DOCUMENT 00 91 13

Addendum Number Two

PROJECT: ITD D5 Maintenance Building Addition and
Renovation and New Brine Facility
Blackfoot, Idaho

PROJECT NO.: 22569

MAINT. BLDG. ROOF PLAN AND ROOF DETAILS

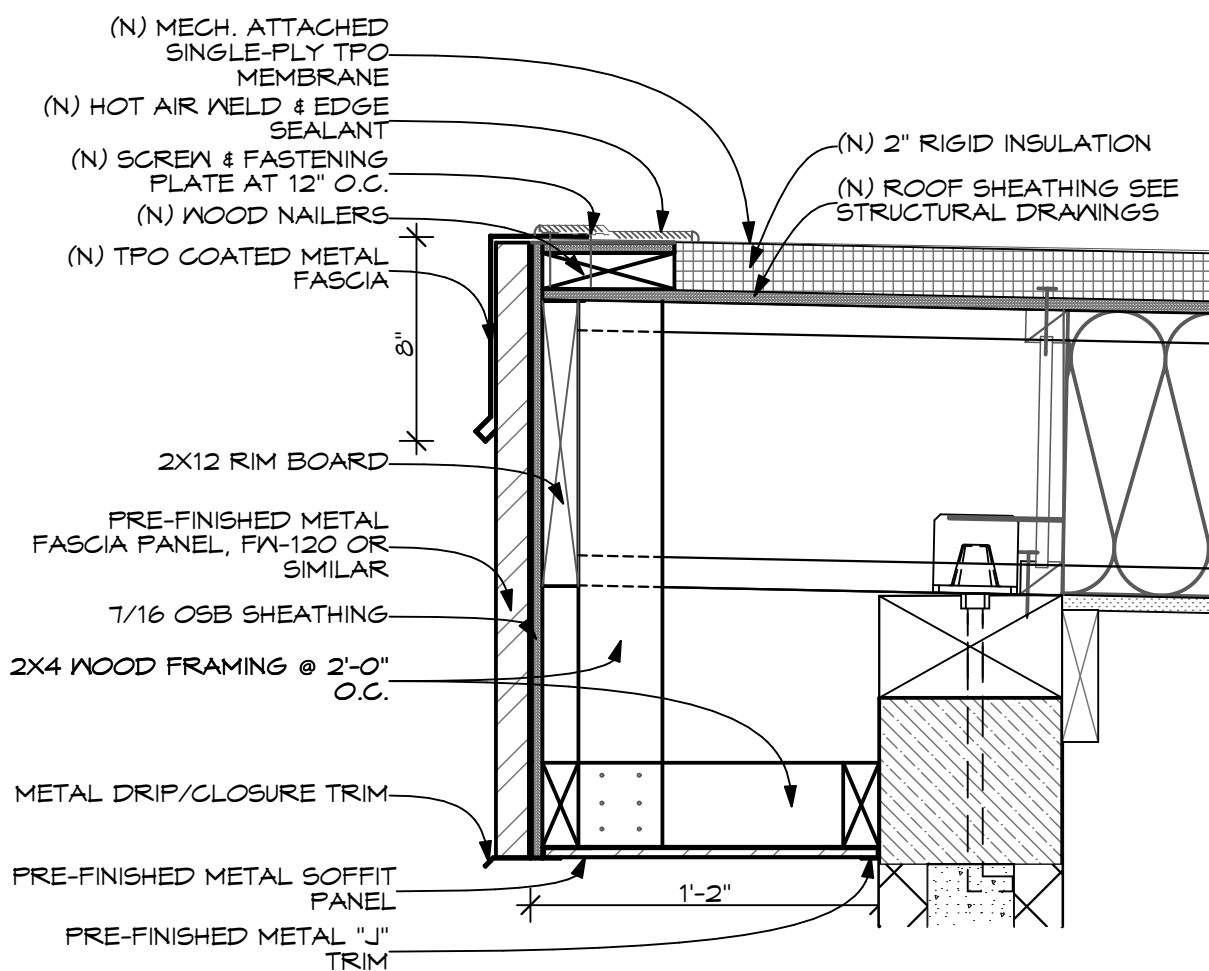
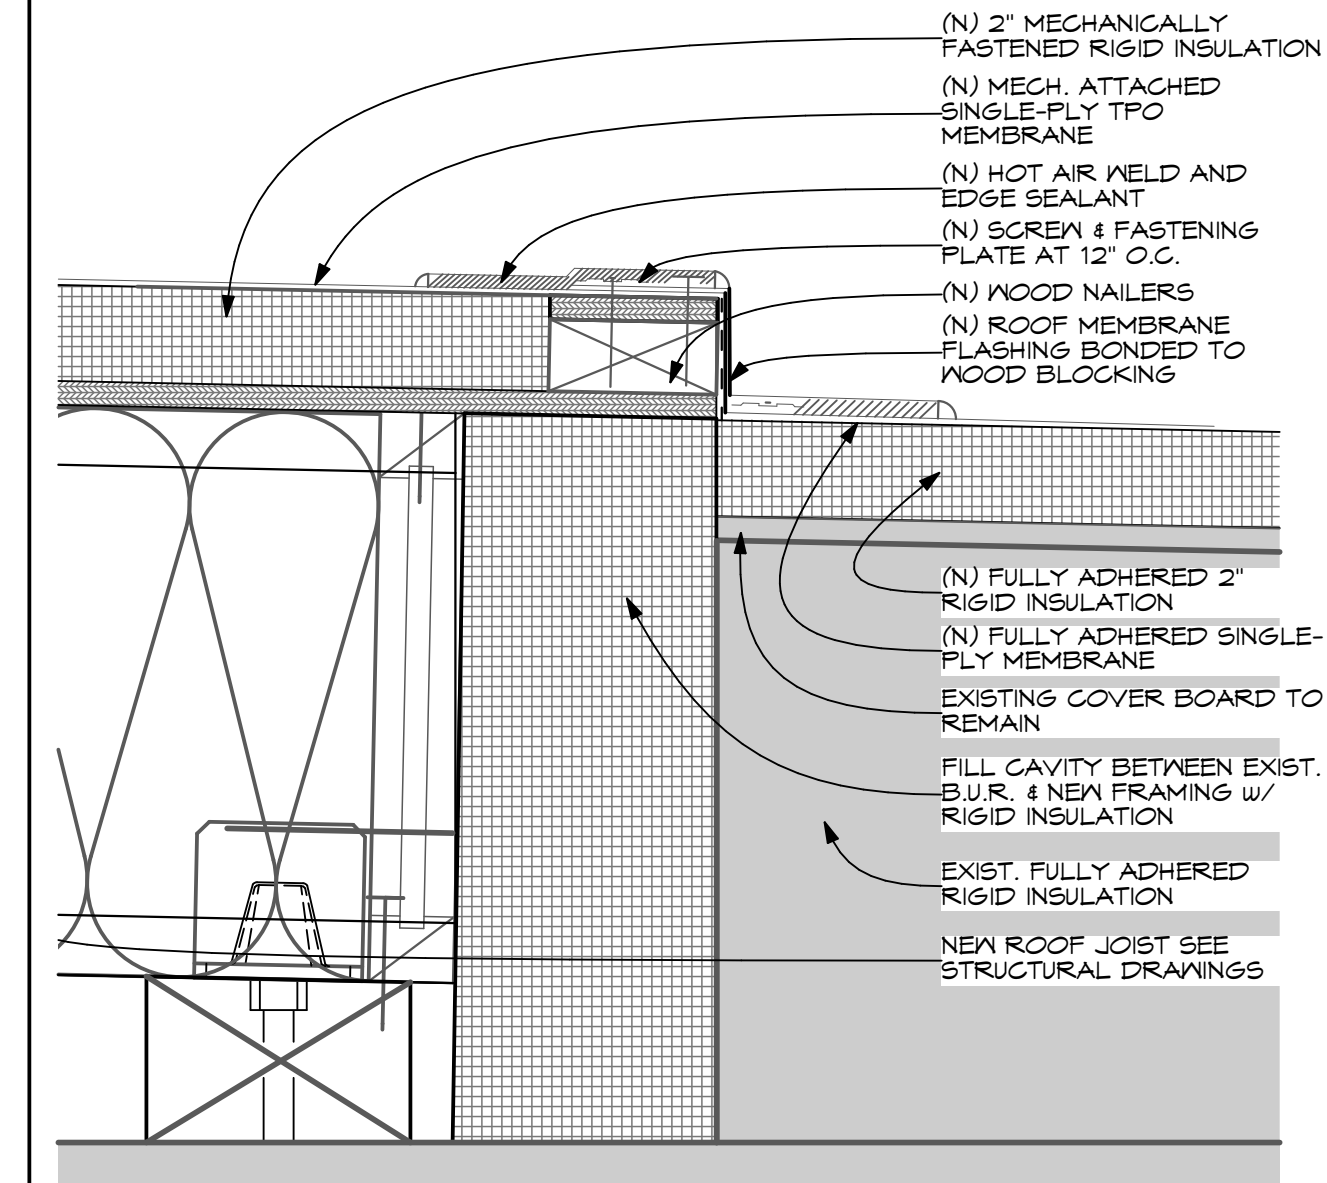
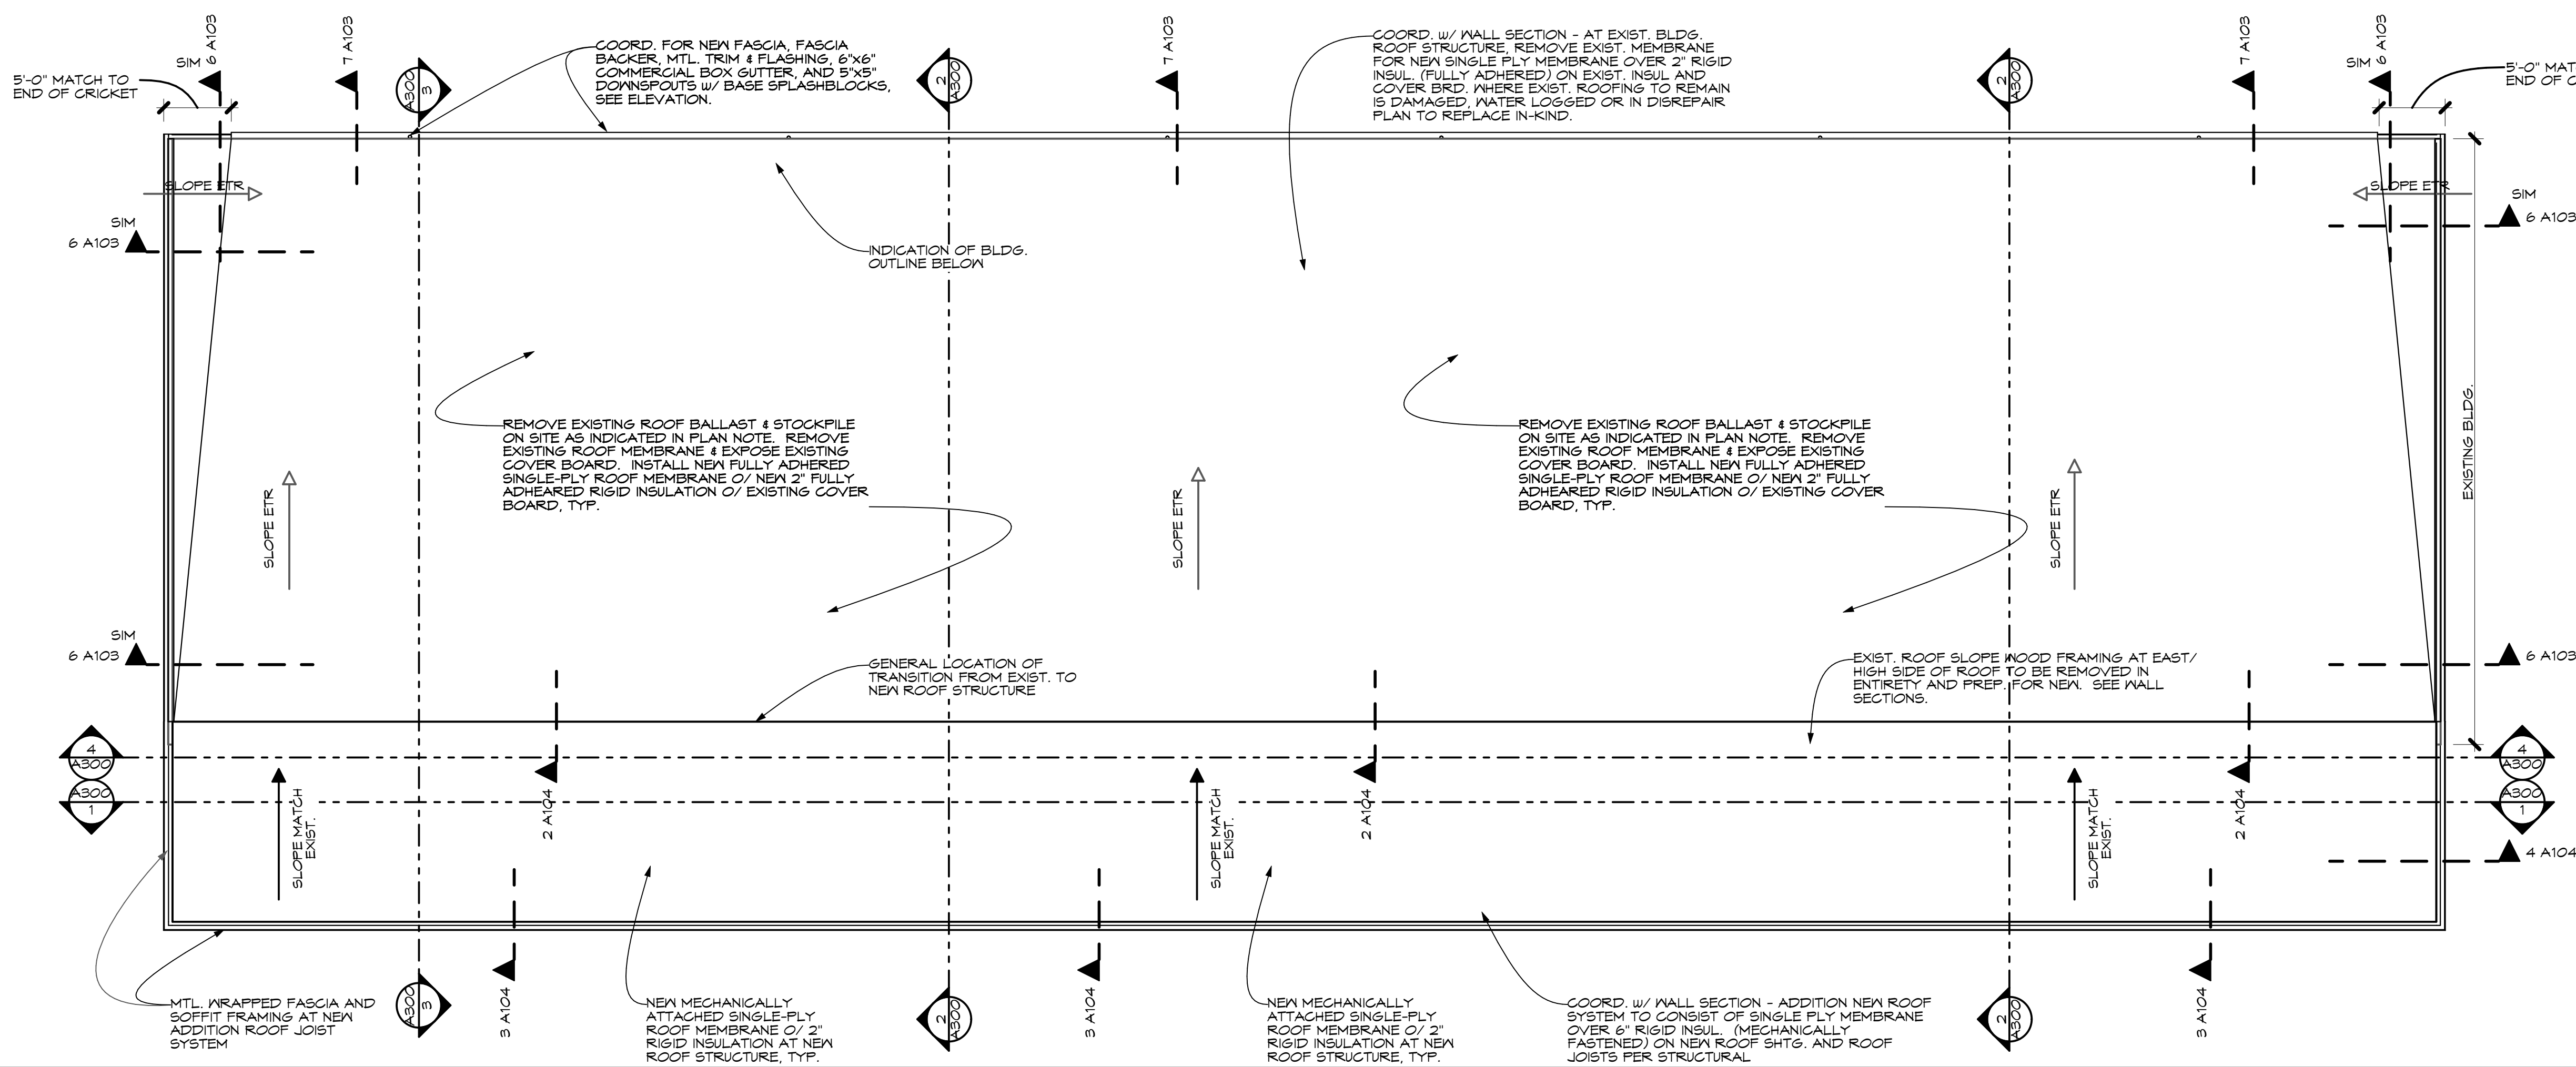
3. Replace Sheet A104 – Maint. Bldg. Roof Plan and Roof Details with attached Sheet A104 – Maint. Bldg. Roof Plan and Roof Details. Revisions are as follows.

- a. Revised details 1, 2, and 3 on drawing sheet
 - b. Provided notes on plan for clarification of single-ply membrane and ballast removal.
4. Add Sheet A104.1 – Typical Roof Details.
